Create items 154-161 in the BoM using the information provided above. Leave Note and Ident columns blank

DATE	M. ALES	03/29/04	 Westinghouse ELECTRIC COMPANY LLC - NUCLEAR FUEL COLUMBIA, SC USA				
CHGD	-	-					
DATE	B. HEMPY	03/12/04	SAFETY RELATED ITEMS TRAVELLER XL & STD				
MSGD	S. PALMER	03/22/04					
DATE	J. COILE	03/22/04					
DATE	W. HERWIG	03/23/04					
DATE	G. SUMMER	03/22/04					
DATE	-	-	DATE	FROM NO	QWSG NO	10004E58	REV
APRD	-	-	SCALE	1:1	WDSG(FSR)	-	4
APRD	-	-	SHEET 1 of 8

SAFETY RELATED ITEMS	
TRAVELLER XL & STD

LOWER OUTERPACK ASSEMBLY
(CLAMSHELL INSTALLED)

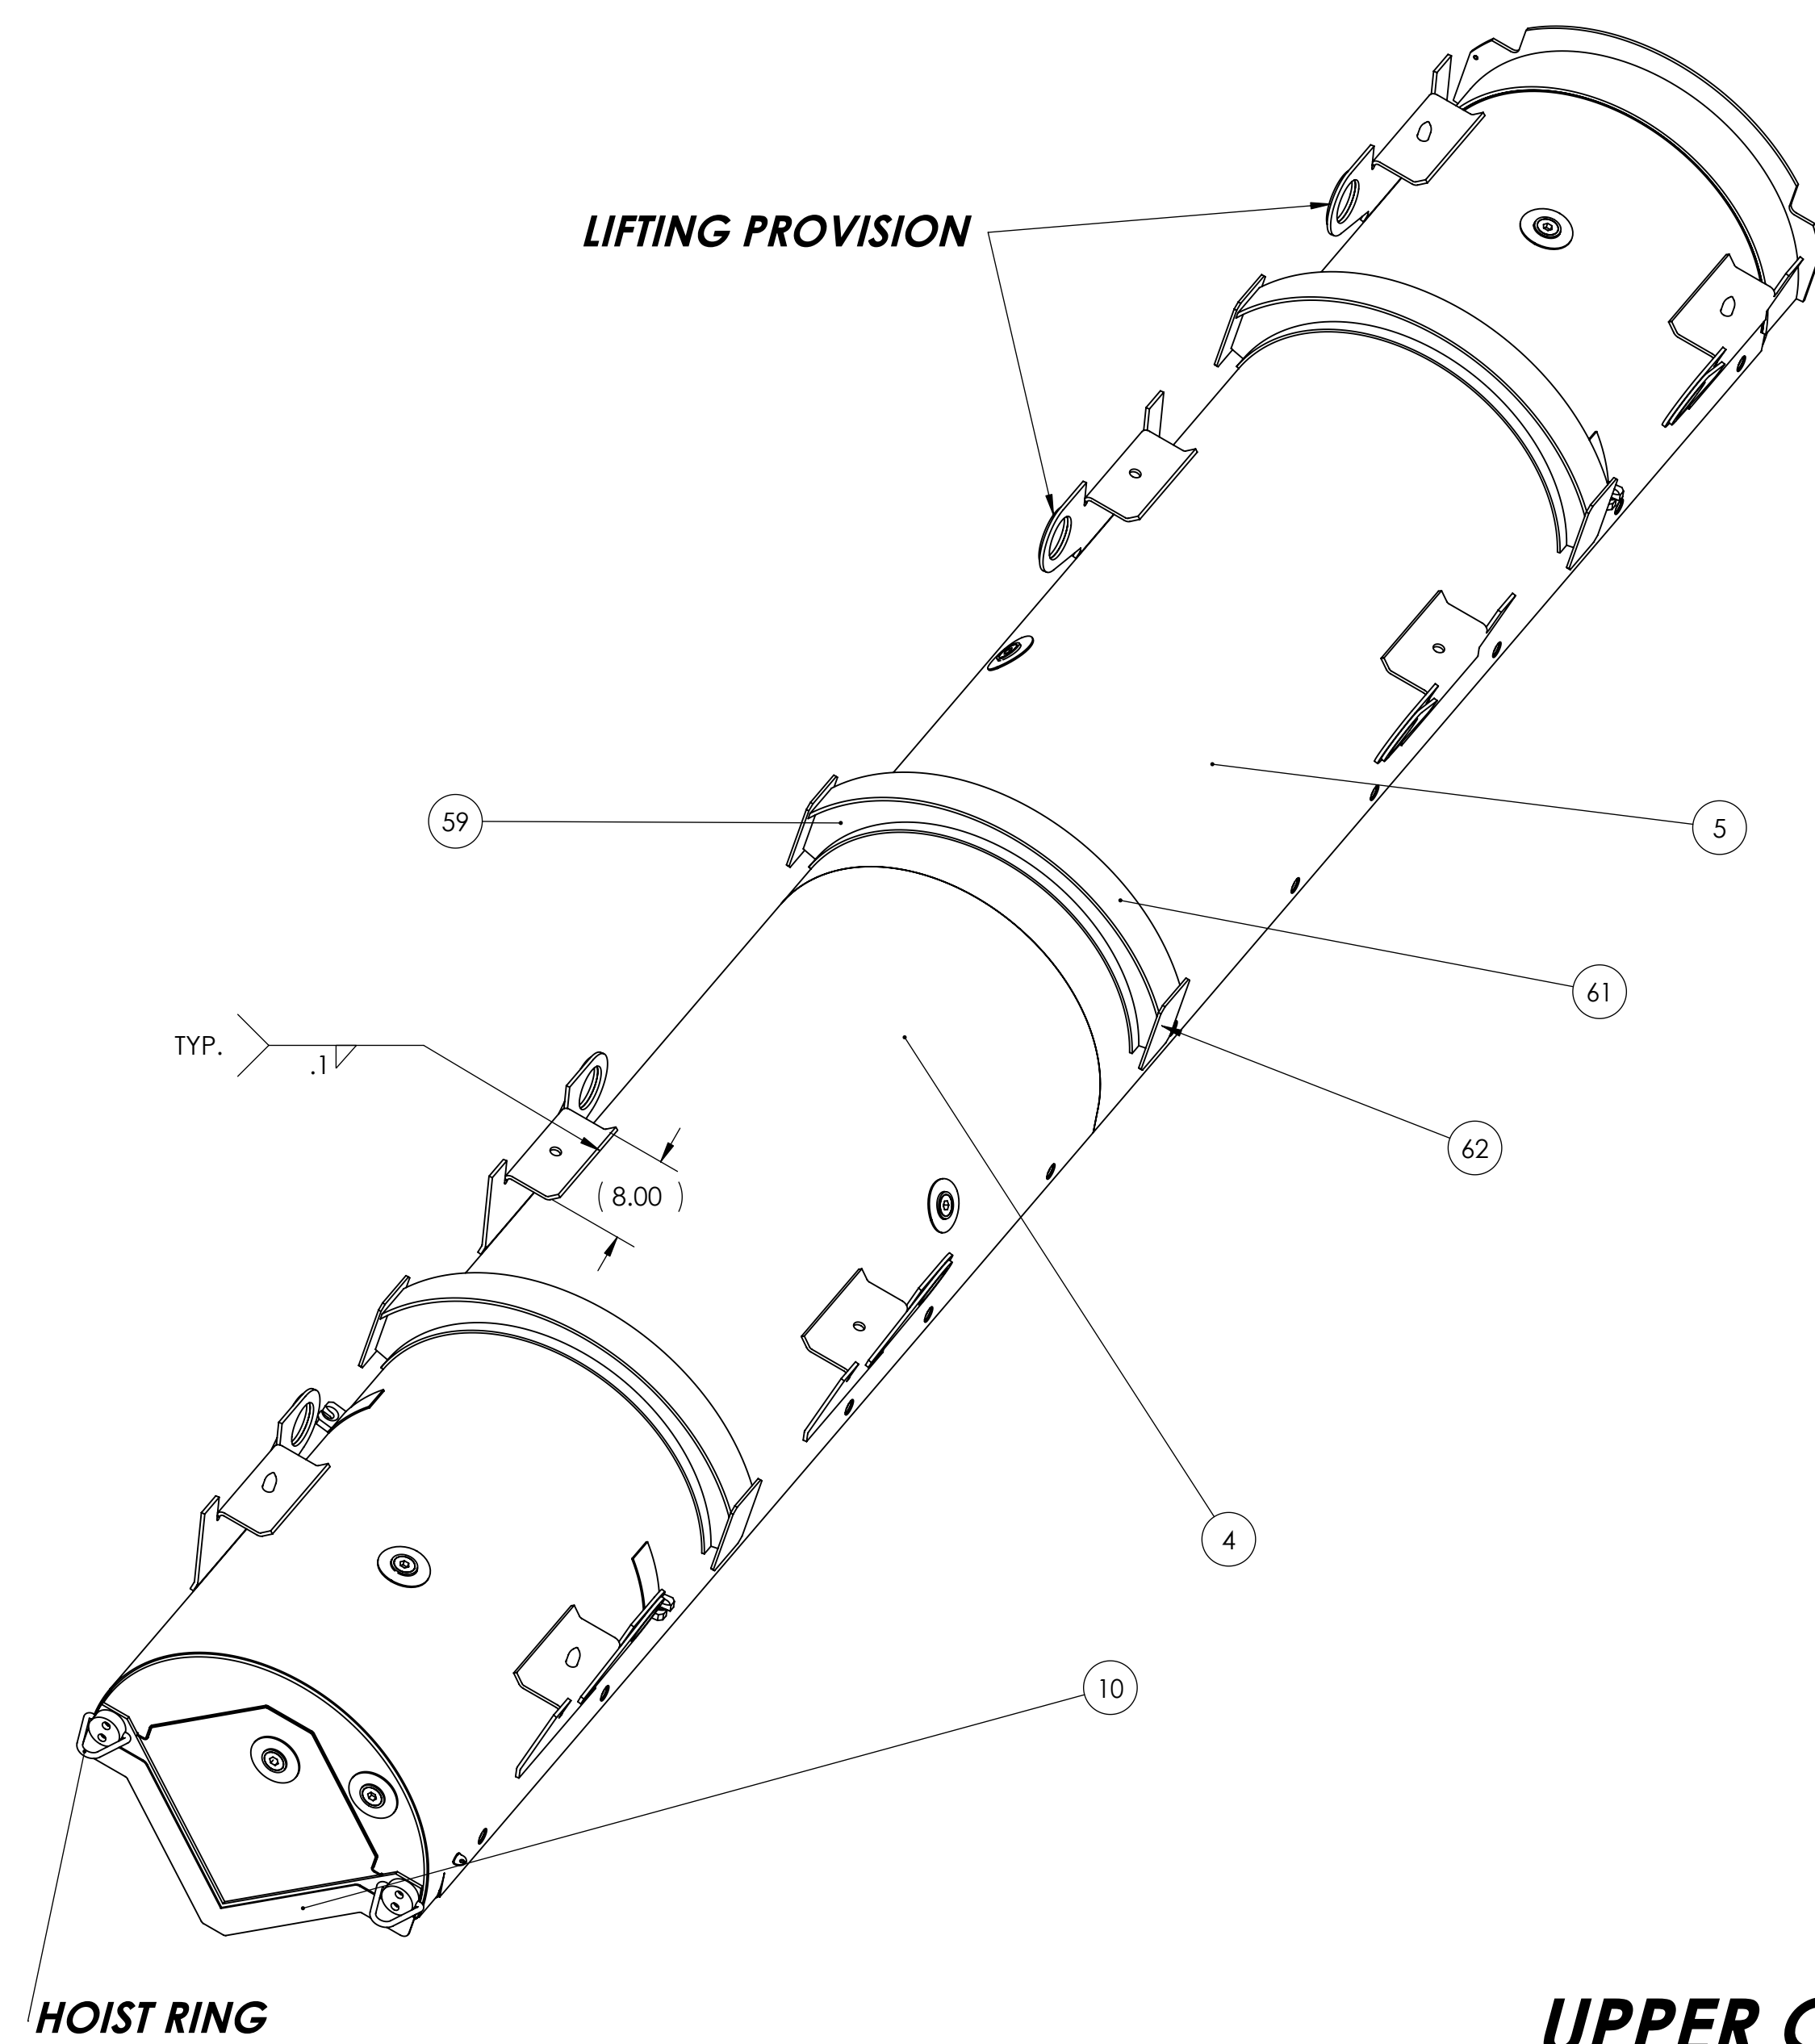
Add depiction of square heat seal from the bottom rail across the top rail, over surface of lip, then to the outer edge of the opposing bottom rail.

Replace depictions of circular heat seals with depiction of square heat seal.

Remove depictions of circular heat seal on upper rails

Add depiction of square heat seal over surface of lip.

Remove weld call-out

Remove depiction of circular heat seal on upper rail

Remove top side weld call-out

SHOCK MOUNT SPACING - XL

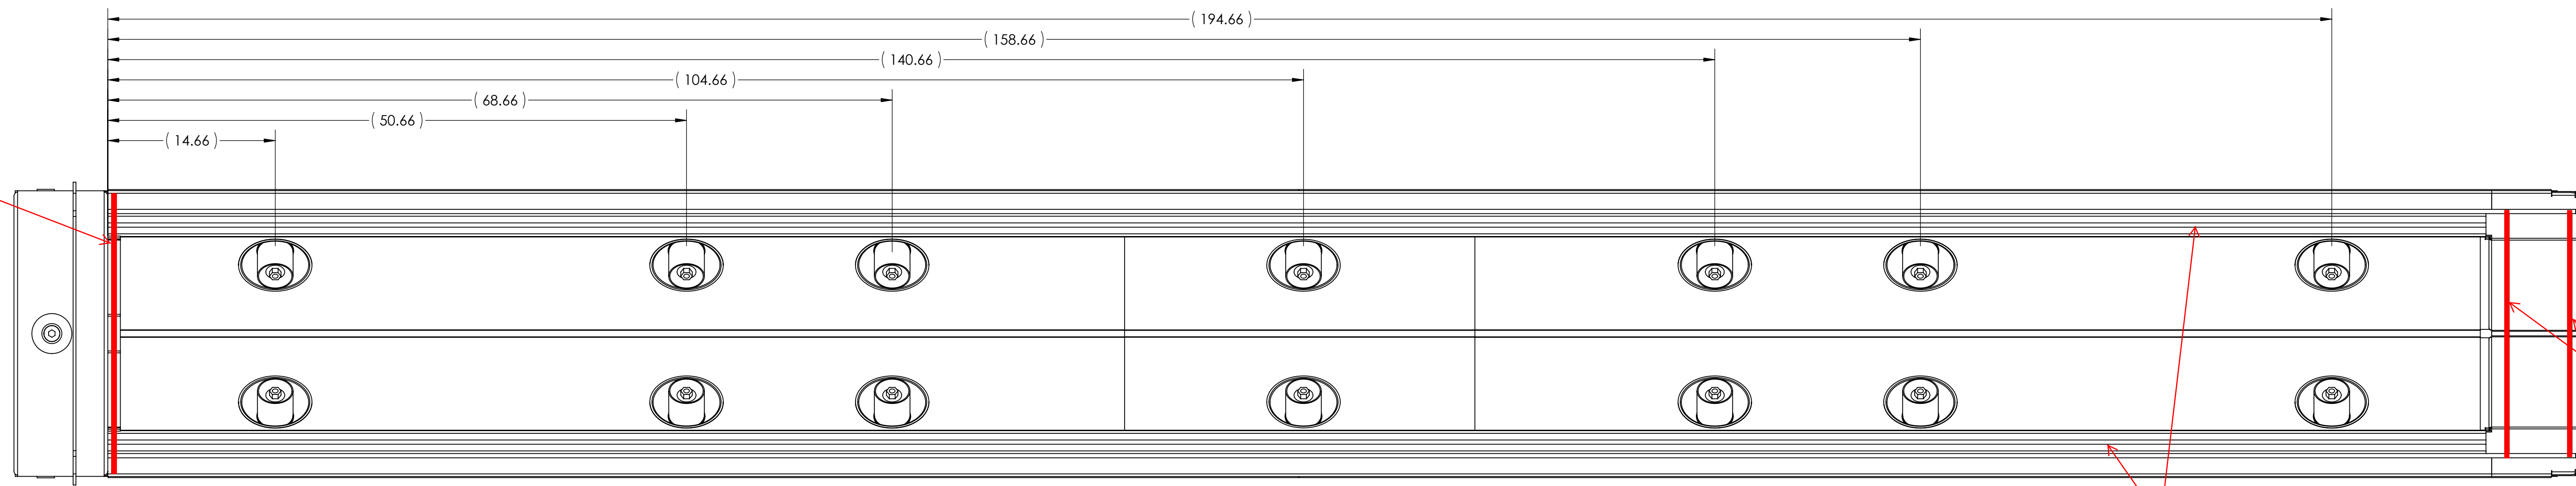
Add depiction of square heat seal from the bottom rail across the top rail, over surface of lip, then to the outer edge of the opposing bottom rail.

Remove depictions of circular heat seal on upper rails

Replace depictions of circular heat seals with depiction of square heat seals.

SHOCK MOUNT SPACING - STD

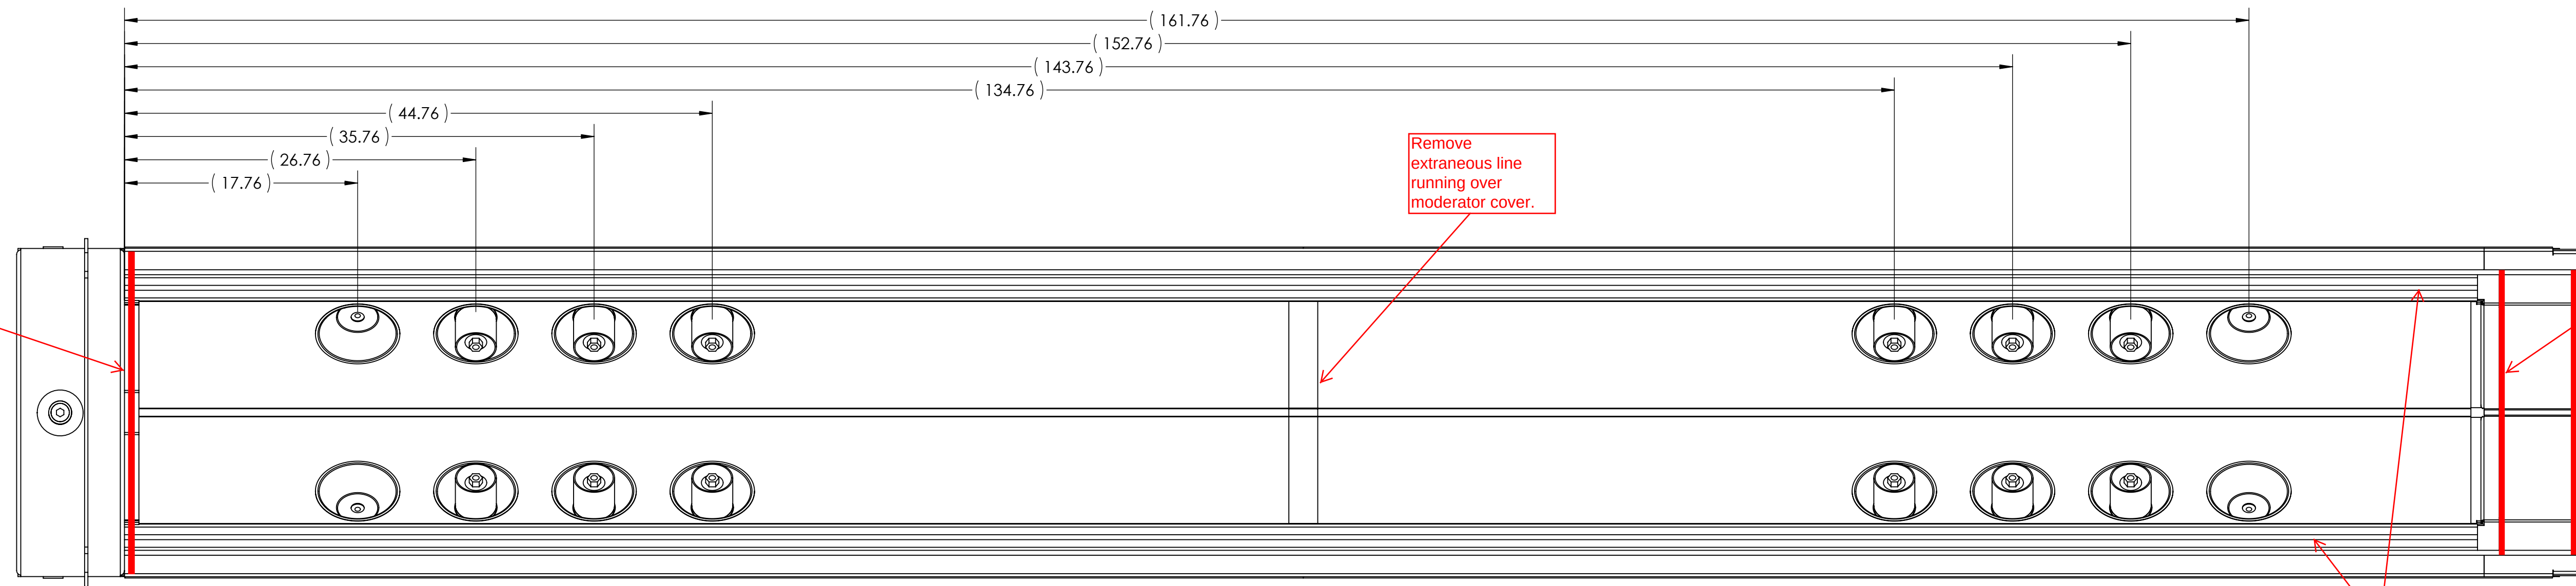
Add depiction of square heat seal from the bottom rail across the top rail, over surface of lip, then to the outer edge of the opposing bottom rail.

Remove depictions of circular heat seal on upper rails

Replace depictions of circular heat seals with depiction of square heat seal.
